ADDENDUM # 1
11/04/2022

RFP#22-75
FLOC DRIVE ROOM FLOOR DRAIN IMPROVEMENTS
ANN ARBOR WATER TREATMENT SERVICES UNIT

P-101

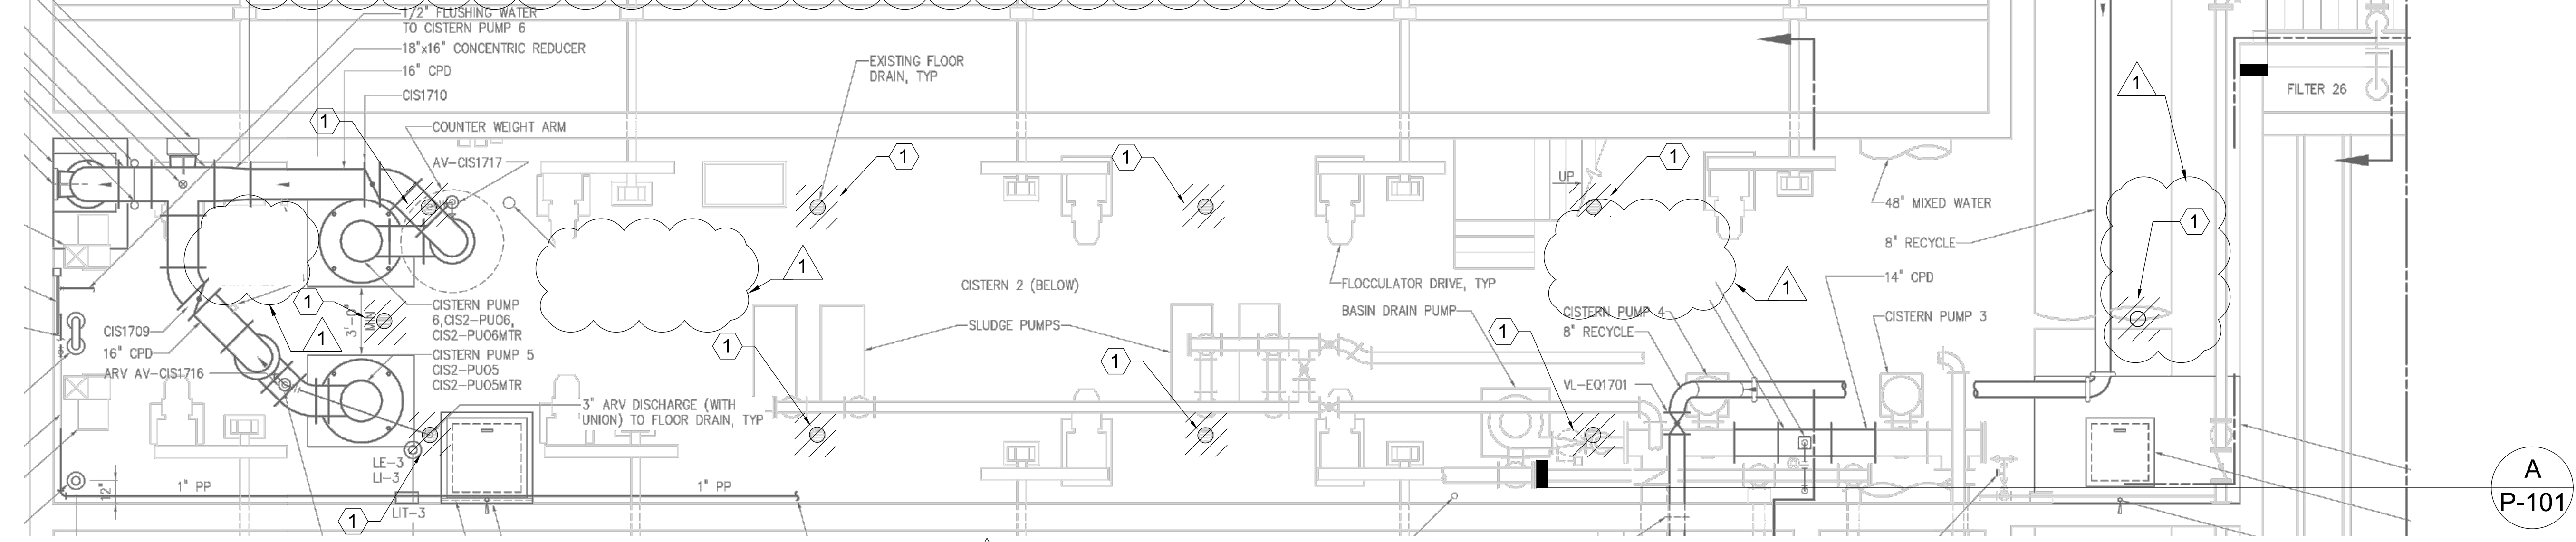
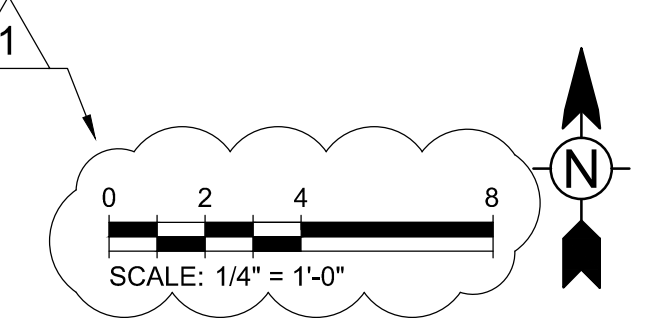
- Q6. Can additional details of the cistern be provided?
A6. Additional photos have been included on reissued sheet.
- Q7. Is a temporary pump needed for the sump during installation of new pumps?
A7. Successful bidder shall sequence the sump pump demolition and installation of new pump to keep one pump in service throughout work.
